# UNITED STATES PATENT AND TRADEMARK OFFICE

APPLICATION NO.	FILING DATE	FIRST NAMED INVENTOR	ATTORNEY DOCKET NO.	CONFIRMATION NO.
10/816,362	03/31/2004	Adam Merzon	1668-5 RCE	6083

<b>Office Action Summary</b>	Application No. 10/816,362	Applicant(s) MERZON, ADAM	
	Examiner Michael W. Talbot	Art Unit 3722

## DETAILED ACTION

Fig. 2

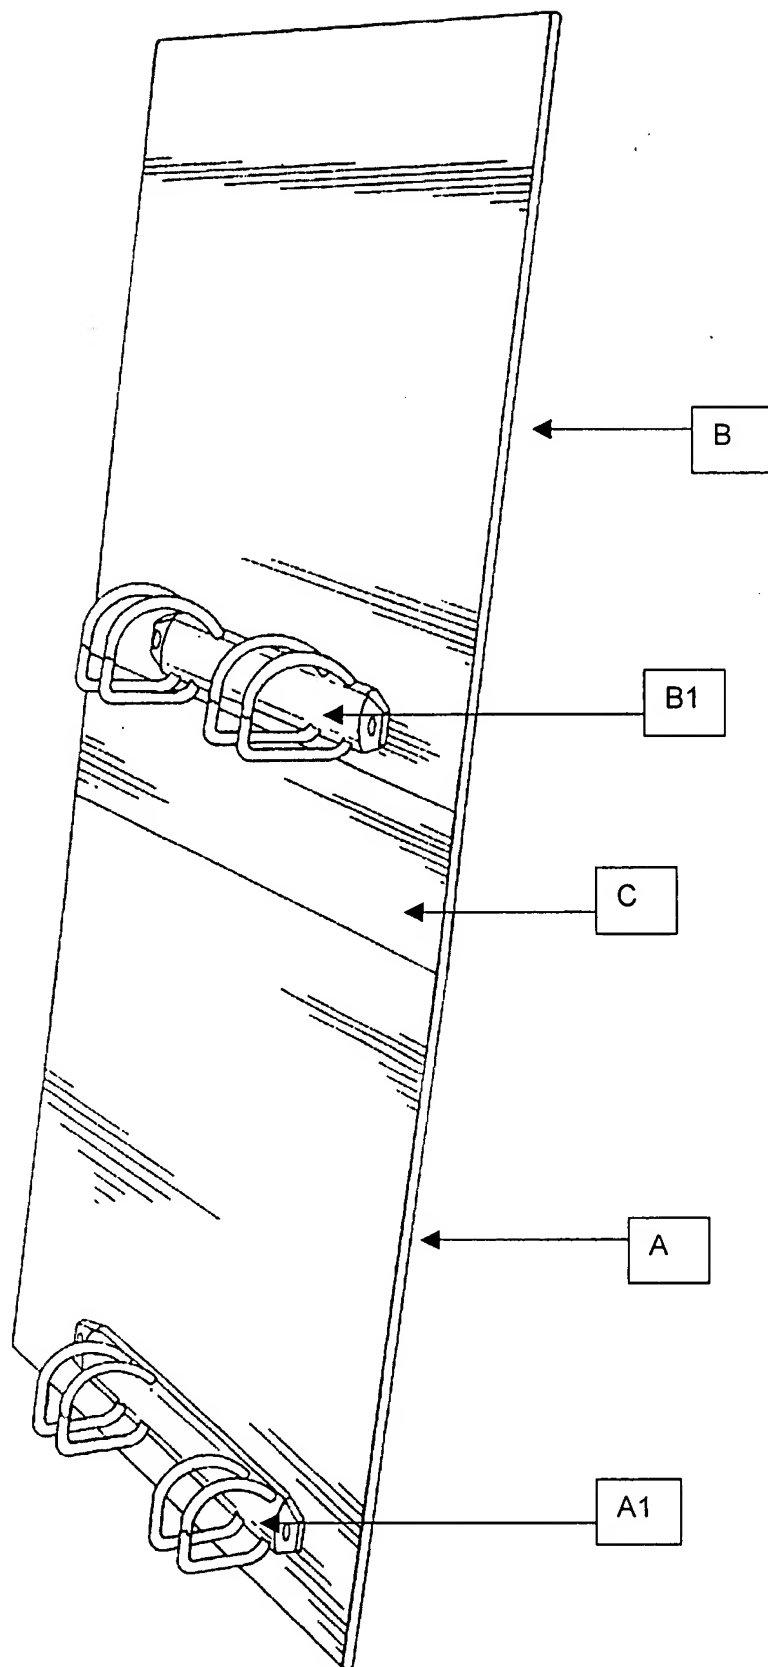
10. Claims 1-5 and 25-27, as best understood, are rejected under 35 U.S.C. 103(a) as being unpatentable over Lepisto (D467,966) in view of Lehnert. Lepisto discloses in Fig. 2 below, a binder arrangement comprising: a pair of covers (A and B) each hingedly carried by an abutting extreme boundary of a hinge (C); each of the covers constructed with a pivoting surface that pivots 90 degrees against the hinge (see Fig. 1); a first set of binders (A1) permanently fixed at a location and parallel to the hinge and carried by one of the covers (A); a second set of binder (B1) permanently fixed at a location and adjacent and parallel to the hinge by the other one of covers (B); wherein the binder are offset from one another and do not overlie each other when the arrangement is disposed in a closed position (see Fig. 1); and wherein the binders also include a plurality of D-shaped ring paper straightening fastening mechanisms (see Fig. 2). However, Lepisto does not disclose: wherein the first set of binders are adjacent to the hinge; wherein the one of the binders is offset relative to the other one such that one binder is spaced farther away from a centerline of the hinge than the other one of the binders; wherein the offset is between 1/4 of an inch and 3/4 of an inch; wherein the offset is 1/2 of an inch.

Lehnert discloses in Fig. 2, a binder arrangement wherein a set of binders can be placed at any desirable arrangement location on the cover as desired by the end user. Therefore, it would have been obvious to one having ordinary skill in the art at the time the invention was made to modify Lepisto's binder with a binder location that can be placed any desirable location on the cover as taught by Lehnert for providing a cover having a binder location at any point on the cover as desired by applicant.

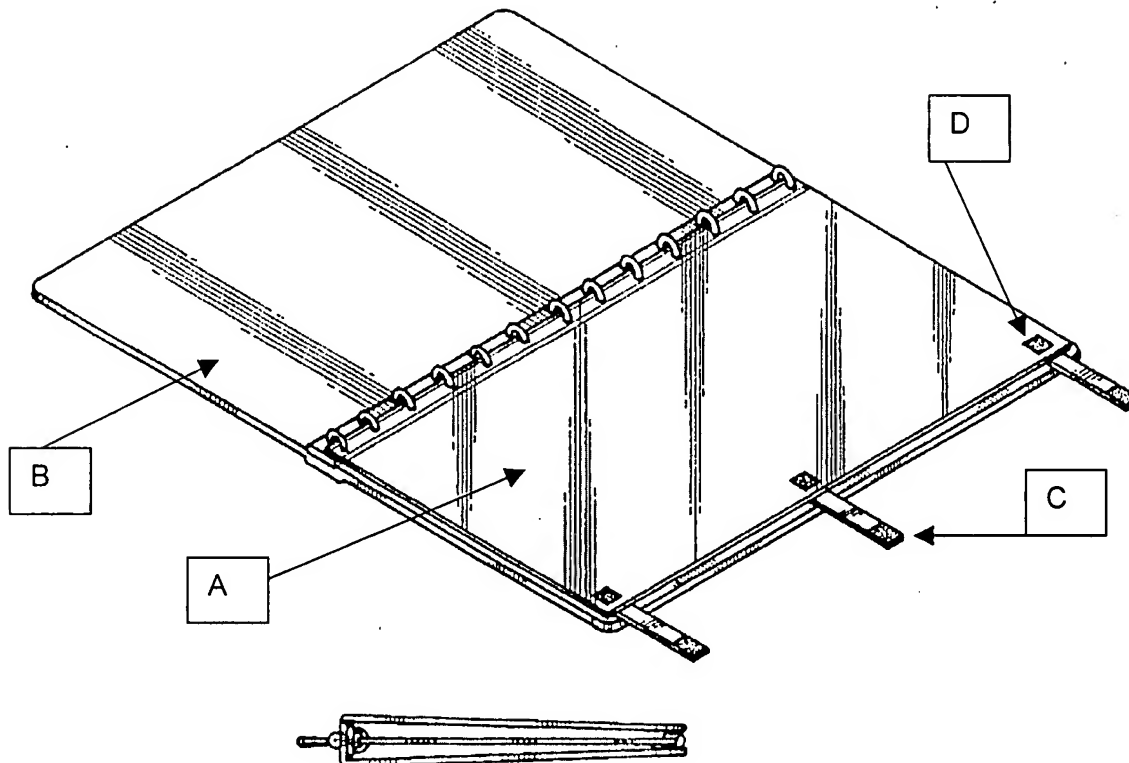
12. Claims 6-9 and 21, as best understood, are rejected under 35 U.S.C. 103(a) as being unpatentable over Lehnert in view of Zimbelman (D364,640). Lehnert discloses a binder arrangement comprising all the elements as disclosed in claim 1, and as set forth above. However, Lehnert does not disclose: wherein one of the binders includes a hold down page that is equipped with a releasable latch that releasably anchors the page to one of the covers; wherein the latch comprises a latch strap carried by the one of the covers and a latch receiver carried by the hold down page; wherein the latch strap and receiver comprises a hook loop and fastener that releasably secures the page to a perimeter of one of the covers.

Zimbelman discloses in Figs. 1 and 2 below, a binder arrangement comprising: a hold down page (A) that is equipped with a releasable latch receiver (D) that releasably anchors one of the covers (3) to the hold down page through a latch strip (C), releasably securing the page to a perimeter of one of the covers. Therefore, it would have been obvious to one having ordinary skill in the art at the time the invention was made to modify Lehnert's binder arrangement with a hold down page as taught by Zimbelman for providing storage separators.

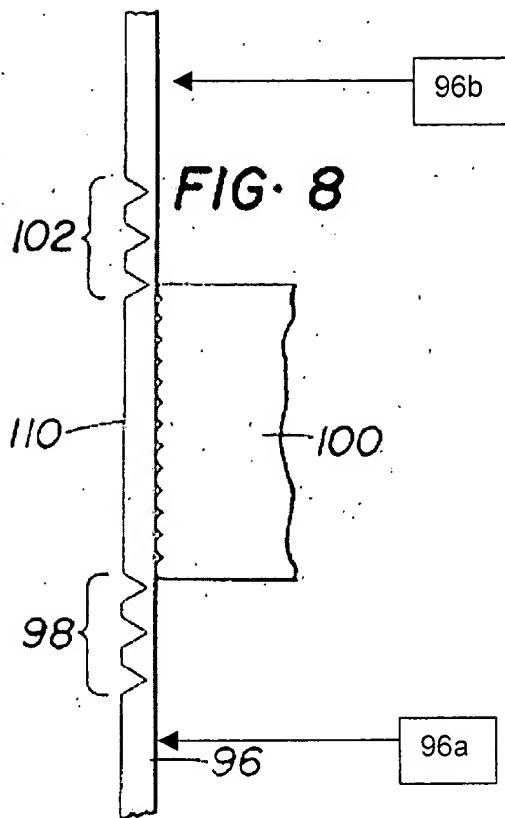
16. Claims 13-19, as best understood, are finally rejected under 35 U.S.C. 103(a) as being unpatentable over Lepisto in view of Lehnert, further in view of Welch (6,209,917). Lehnert discloses a binder arrangement comprising all the elements as disclosed in claim 1, and as set forth above. However, Lehnert does not disclose: wherein each hinge comprises a plurality of scores slits formed in the interior surface of the board; wherein the board is comprised of a fibrous material, or kraftboard; wherein the scores define a region that is compressed to a thickness less than the surrounding thickness of the board; and wherein the spine can include any desirable number of scored hinges.

Welch discloses a binder arrangement comprising: wherein the spine and covers are defined by a board that includes spaced apart integrally formed hinges (45), wherein each hinge comprises a plurality of scores slits formed in the interior surface of the board (col. 6, lines 1-30, and seen in Fig. 6); wherein the board is comprised of a fibrous material, or kraftboard (abstract); wherein the scores define a region that is compressed to a thickness less than the
